Technical Service Information

AUDI 4000/5000 SERIES LATE AND/OR NO UPSHIFTS "COLD ONLY"

Figure 1

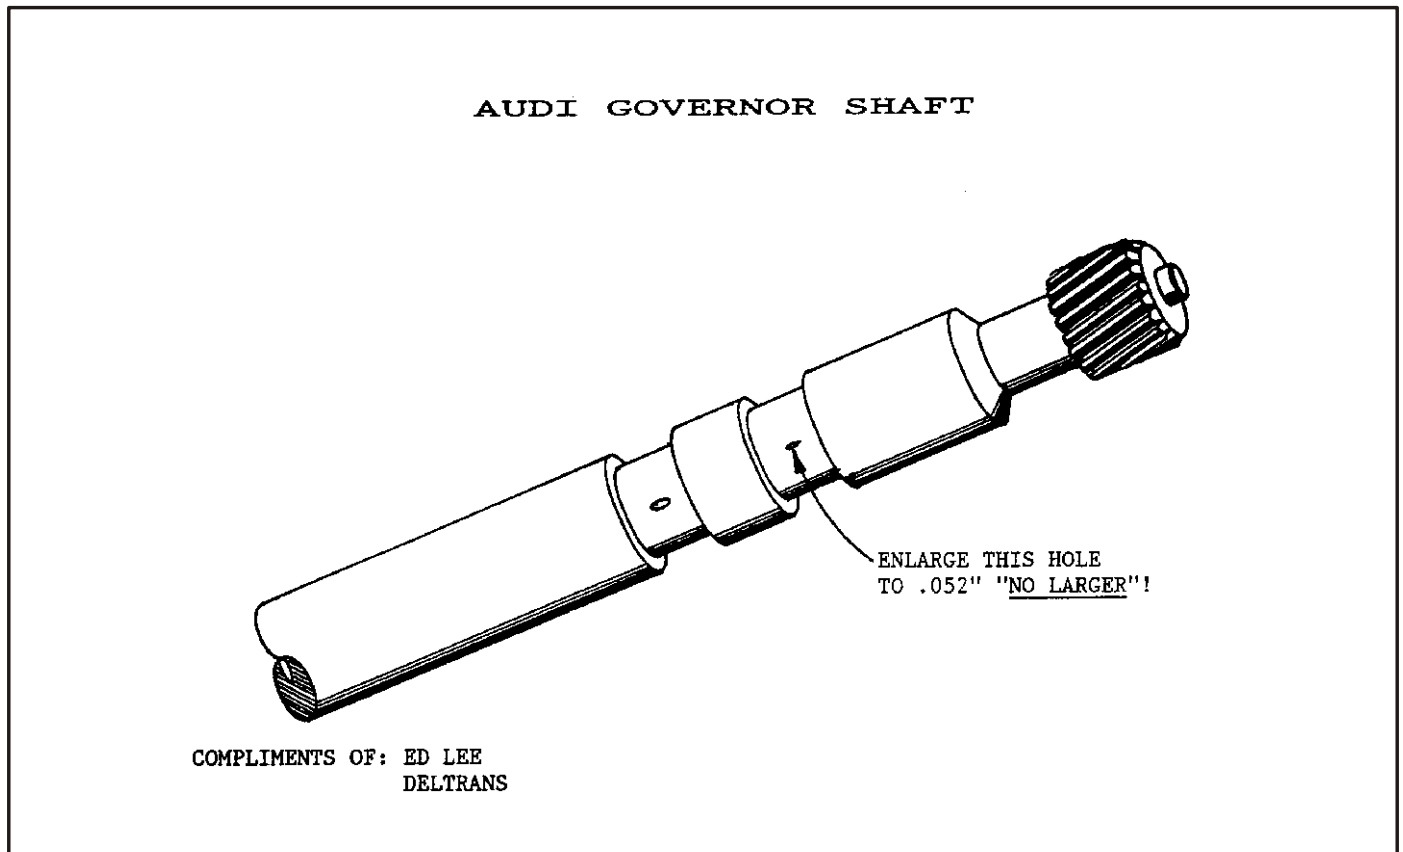
- COMPLAINT:** Some Audi 4000-5000 series vehicles may experience late upshifts and/or no upshifts "COLD ONLY". After the transmission fluid is warm, the transmission shifts properly for the rest of the day.
- CAUSE:** If all other possibilities have been eliminated, the cause may be not enough drive oil being fed to the governor. The volume of COLD oil that can get through the governor shaft orifice may not be sufficient to return governor pressure to the shift valves in the valve body.
- CORRECTION:** Enlarge the small governor shaft feed hole from the present size to .052", "NO LARGER". The governor feed hole is the one that is closest to the governor gear, as shown in Figure 1. The difference in size is very minimal and not much material will be removed from the governor shaft. Be certain to clean all material from governor and the governor shaft after this procedure.
